Access Compliance Report

Public Rights-of-Way

Intersection ID: 3158	Main Street: CHICKADEE_DR	Cross Street: SONG_SPARROW_LN	Location:	N
ADA ID: 03E736E52E41	Ramp Type: BlendTrans2	Initial Pass/Fail: Fail	Overall Compliance: No	Severity Score: 25
Codes/Mitigation Info/Possible Solution		Field Measurements/Component Compliance

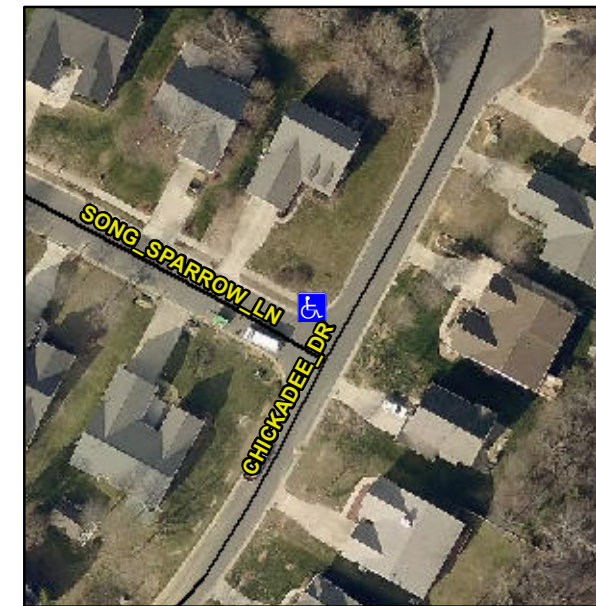
RP < 5%

Not Found, R304.5.3

Compliance	Description	Data	Compliance	Description	Data
N/A	Ramp Length (in)	93.5	Yes	BlendTrans Slope (%)	3.9
Yes	Ramp Width (in)	53.5	No	BlendTrans XSlope (%)	7.0
N/A	Flare Type LT	N/A	N/A	Flare Type RT	N/A
N/A	Flare Slope LT (%)	N/A	N/A	Flare Slope RT (%)	N/A
N/A	Flare Traversable LT?	N/A	N/A	Flare Traversable RT?	N/A
N/A	Landing Length (in)	N/A	N/A	DWS Provided?	N/A
N/A	Landing Width (in)	N/A	N/A	DWS Contrast?	N/A
N/A	Landing Slope (%)	N/A	N/A	DWS Length (in)	N/A
N/A	Landing X Slope (%)	N/A	N/A	DWS Full Width?	N/A
N/A	Landing Curb? (Y/N)	N/A	N/A	DWS Offset (in)	N/A
N/A	Shared Landing?	N/A			
N/A	Gutter Ponding?	N/A	N/A	Gutter Slope (%)	N/A
N/A	Gutter Lip Ht (in)	N/A	N/A	Gutter X Slope (%)	N/A
N/A	Painted X Walk1?	No	N/A	Painted X Walk2?	N/A
	X Walk 1 Direction	To SE		X Walk 2 Direction	N/A
	X Walk 1 Width (in)	N/A		X Walk 2 Width (in)	N/A
	X Walk 1 Slope (%)	6.1		X Walk 2 Slope (%)	N/A
	X Walk 1 X Slope (%)	1.6		X Walk 2 X Slope (%)	N/A

N/A	Ramp inside XWalk1?	N/A	N/A	Ramp inside XWalk2?	N/A
	Road Slope (%)	1.6		Clear Space?	N/A
	Road X Slope (%)	6.1	N/A	Clear Space to XWalk (in)	N/A
N/A	Any Obstructions?	N/A	N/A	Storm Grate/Utility Hazard?	N/A
	Obstruction Type			Storm Grate/Utility Type	
		N/A			N/A
			Yes	Surface Condition? (G/P)	Good
			No	Curb Slope (%)	9.1

Remove & Replace Curb Ramp With Two New Directional Ramps or Equivalent.
